## ON-SITE SEWAGE DISPOSAL SYSTEM HOWARD COUNTY HEALTH DEPARTMENT BUREAU OF ENVIRONMENTAL HEALTH

ADDRESS: 2579 Jennings Chapel Road PROPERTY OWNER: Daniel Ricker

SITE PLAN FOR #2579 JENNINGS CHAPEL ROAD

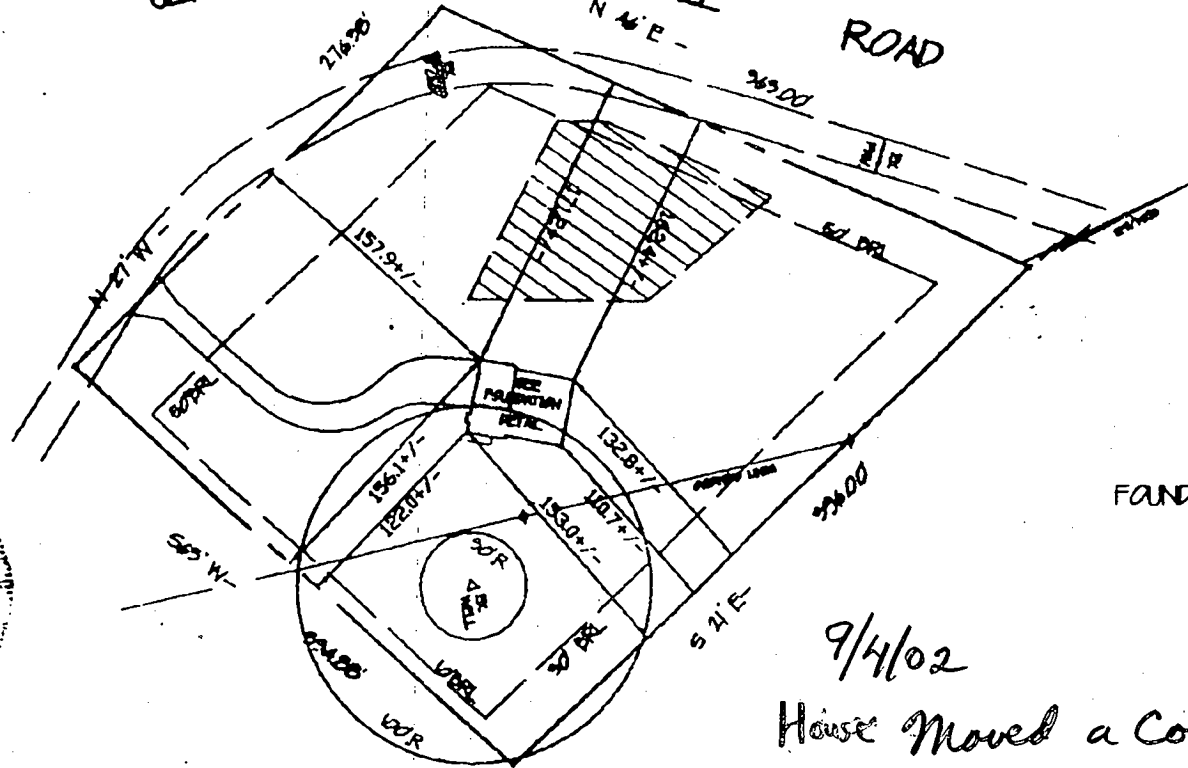
PRE-CONSTRUCTION 9/11/02 lot staked, contours as shown, house corner changed. Move tank closer to SRA, too deep. OK to set DB not exactly;

INSTALLATION in the middle as long as 280' of trench installed (see)

9/12/02 OK to cover all work (see)

FOUNDATION CERTIFICI  
FOR  
#2579 JENNINGS CHA  
TAX MAP 13, GRID 9, PARC  
4TH ELECTION DISTRICT  
HOWARD COUNTY, MARYLAN  
05/21/2002 SCALE 1"=

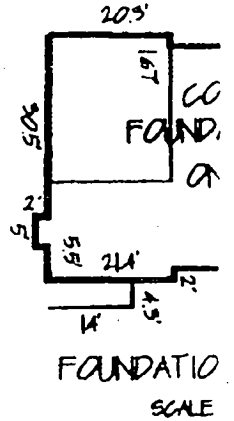
House Moved a Couple  
Feet toward the left  
lot line - O.K.

LOCATION DIAGRAM

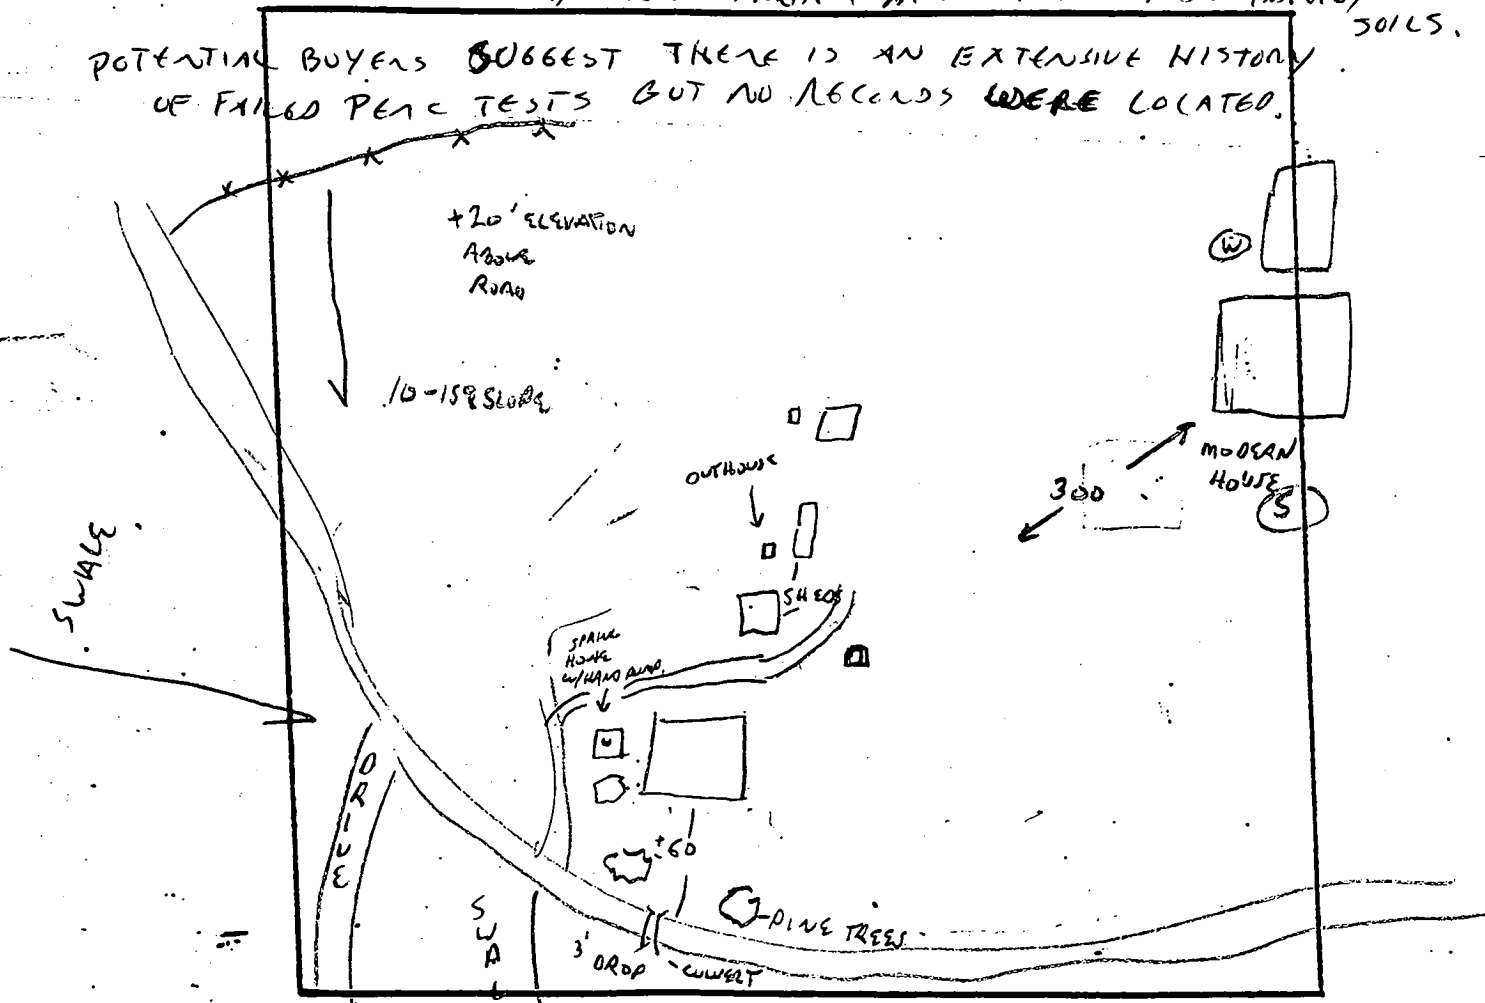
COMMENTS: BURIED DRAIN PIPES VISIBLE - 1" STEEL - CROSSES LOT DIAGONALLY FROM DIRECTION OF MODERN

HOUSE DOESN'T LOOK FUNCTIONAL. POTENTIAL SOA MID OR HIGH ON LOT

IF NOT ROCKY, WATER TABLE IS NOT AN ISSUE EXCEPT ALONG SWALE BY ROAD

REPAIR WOULD REQUIRE PUMP FROM PRESENT HOUSE LOCATION.

CONCLUSION: ELIGIBLE FOR REPAIR (25) PERC, BUT REQUIRE TEST APPLICATION FROM RESPONSIBLE PARTY, NOT CONTRACTOR (TOO MANY)

LOCATION DIAGRAM

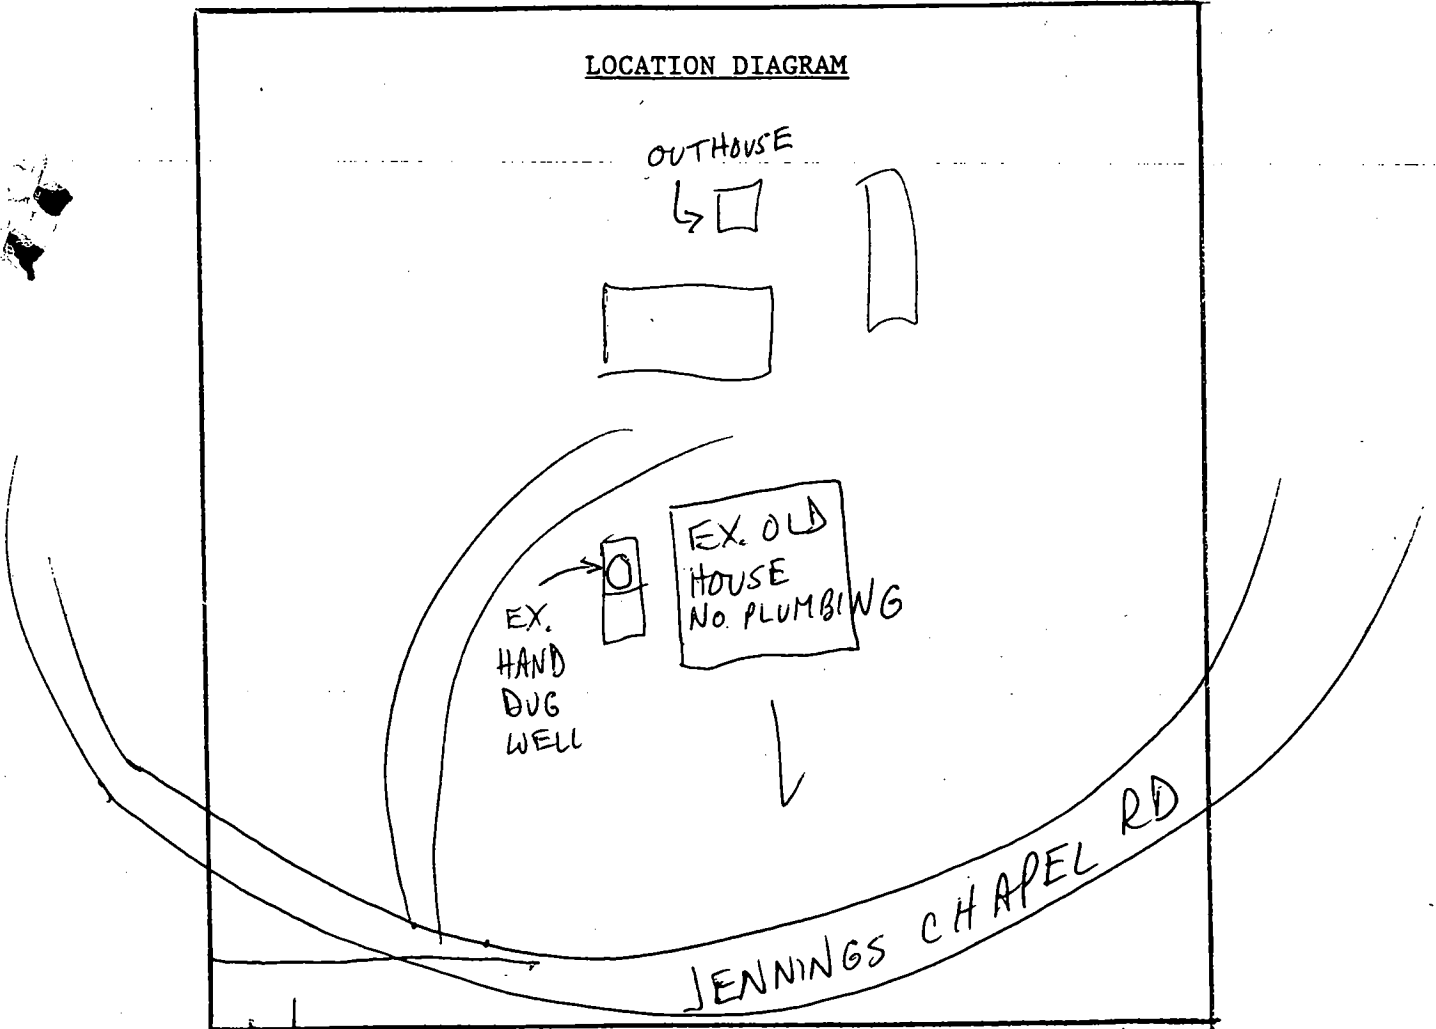
COMMENTS: 12/11/01 OK TO ISSUE DEMO LETTER, HAND DUG TO BE AB. FIRST MR
